PLAT COMMITTEE

PUD-15-12 **Zachary Dwiel**
415 ½ N. Spring St.
Preliminary and final plat approval of a 12-lot, zero-lot line residential subdivision to be known as Dandelion Village

BLOOMINGTON PLAT COMMITTEE **CASE #: PUD-15-12**
STAFF REPORT **DATE: April 9, 2012**
LOCATION: 415 ½ N. Spring Street

REQUEST: The petitioner is requesting preliminary and final plat approval of a 12-lot zero-lot-line subdivision to be known as Dandelion Village.

FINAL PLAT

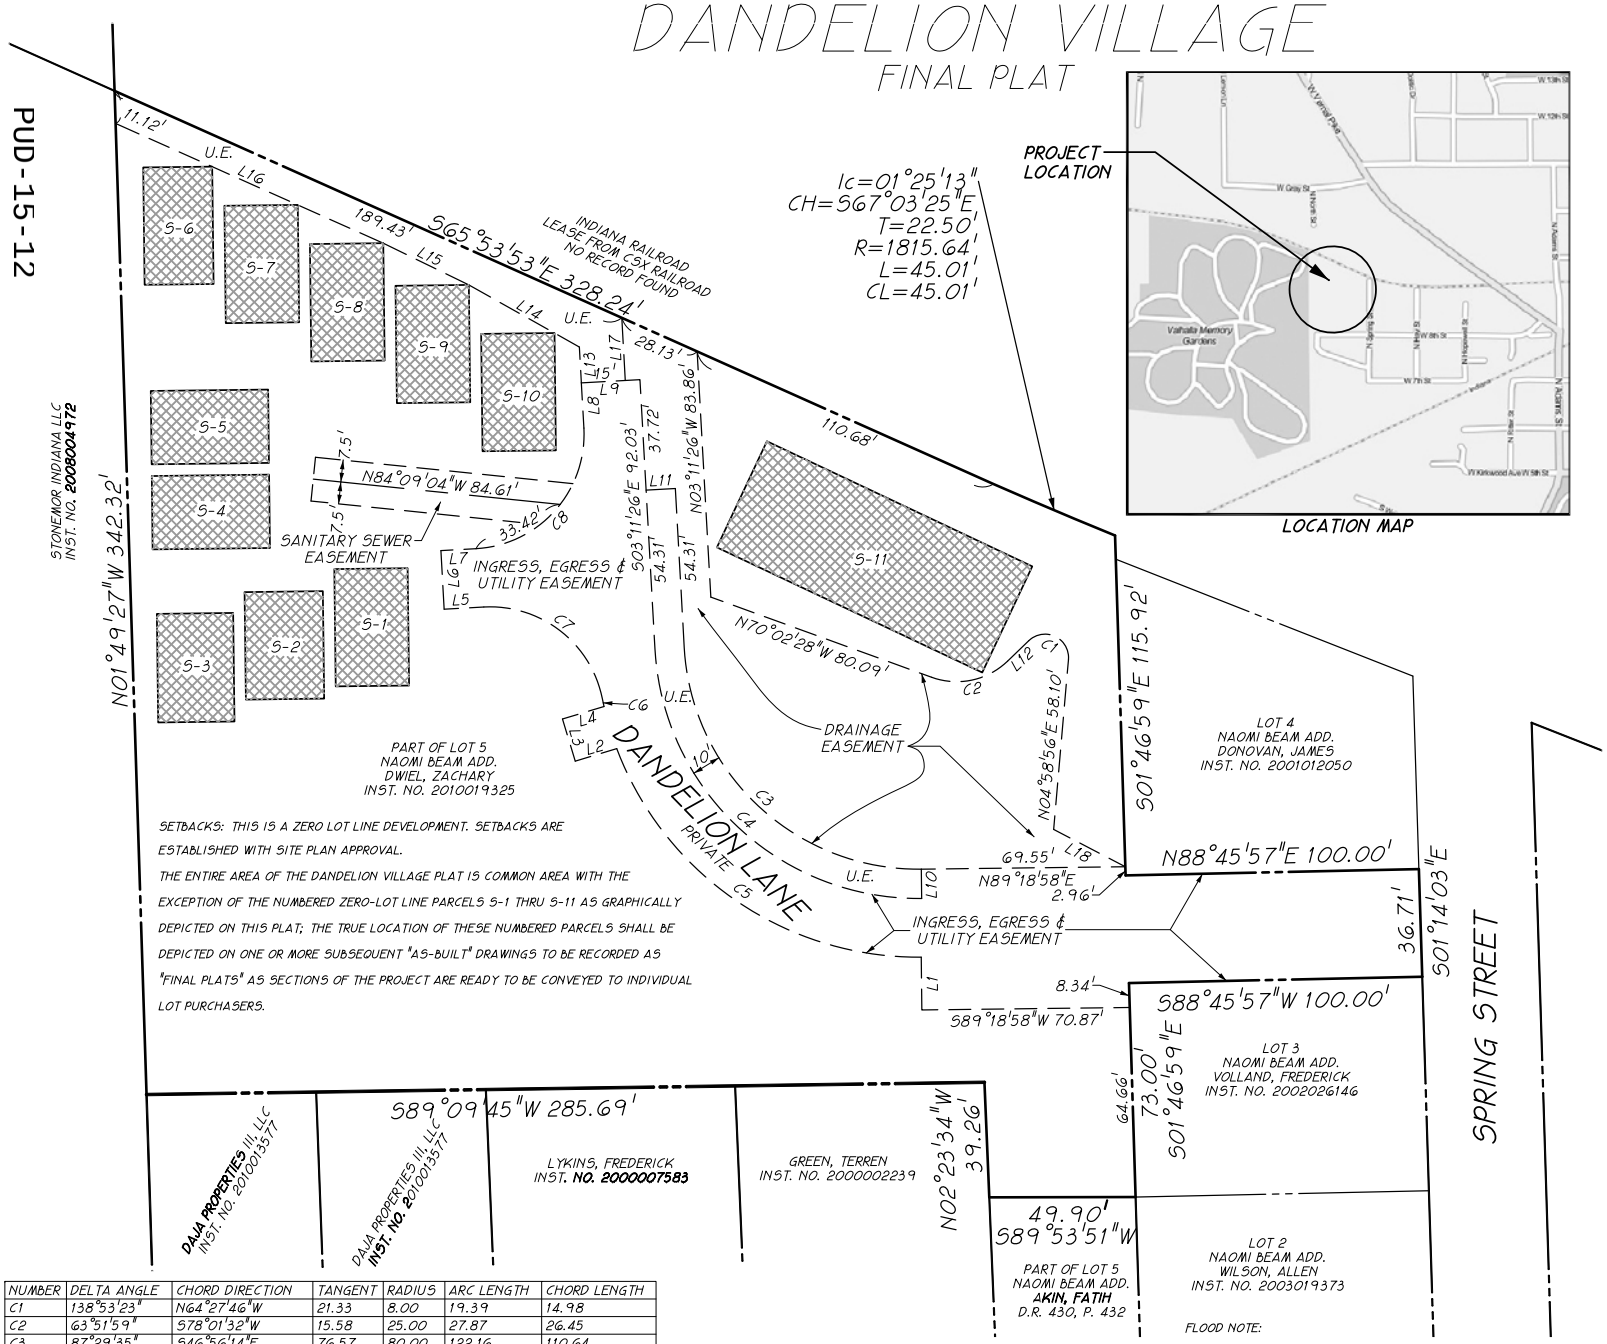
Right-of-Way: This plat has no new public streets. However, dedication of right-of-way along N. Spring Street 25 feet from the street centerline is required and shall be shown on the plat prior to signature.

Drainage/Utilities: Overall utility feasibility was reviewed with PUD approval. All necessary easements have been shown on the plat.

1. Prior to plat signature, dedicated right-of-way of 25 feet from the centerline shall be shown on plat.
2. Prior to plat signature, the petitioner must work with staff to finalize subdivision covenants and Facilities Plan.
3. Prior to plat signature, addresses must be shown on the plat.
